STAFF REPORT
(One-Step Final Plat)

CASE NUMBER: SUB 2005-04 -- SAVE-A-LOT ADDITION

OWNER/APPLICANT: Power CDC Development Corp., Inc., 1802 N. Hydraulic, Wichita, KS 67214

LOCATION: West of Hillside, North side of 13th St. North

VICINITY MAP

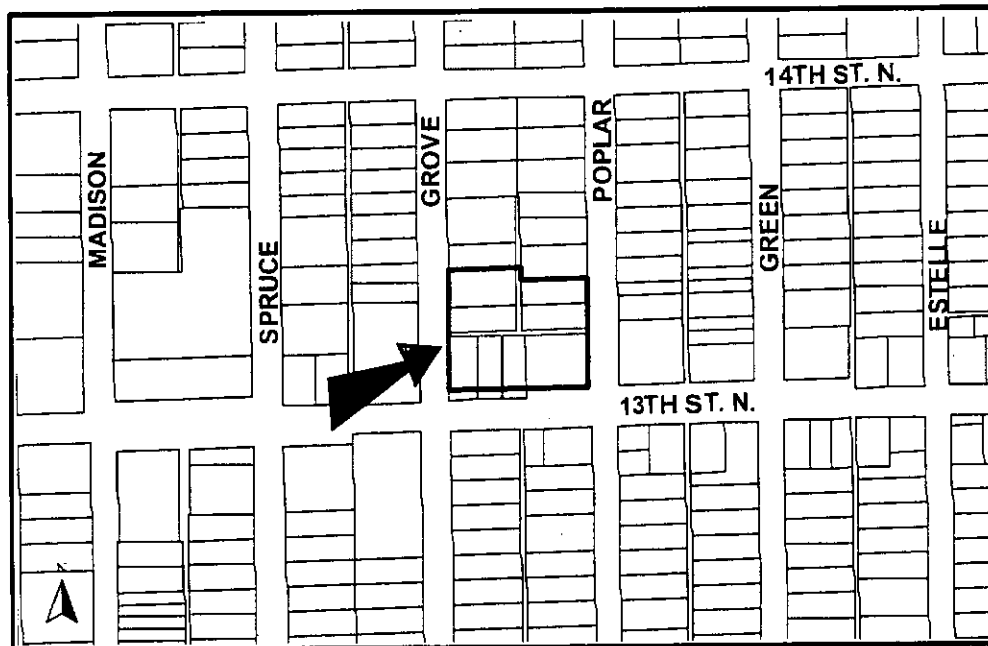
- F. Traffic Engineering needs to comment on the need for additional right-of-way along 13th St. to conform with the 60-ft half-street right-of-way required by the Access Management Regulations.

- G. Poplar street needs to be labeled correctly.
- H. Since the vacation of the north-south alley has created an off-site stub, the Applicant shall contact the adjoining landowner requesting that a vacation request be submitted for the remaining segment of this alley

- I. 13th St. N should be labeled correctly.
- J. The Applicant is reminded that a platting binder is required with the final plat. Approval of this plat will be subject to submittal of this binder and any relevant conditions found by such a review.
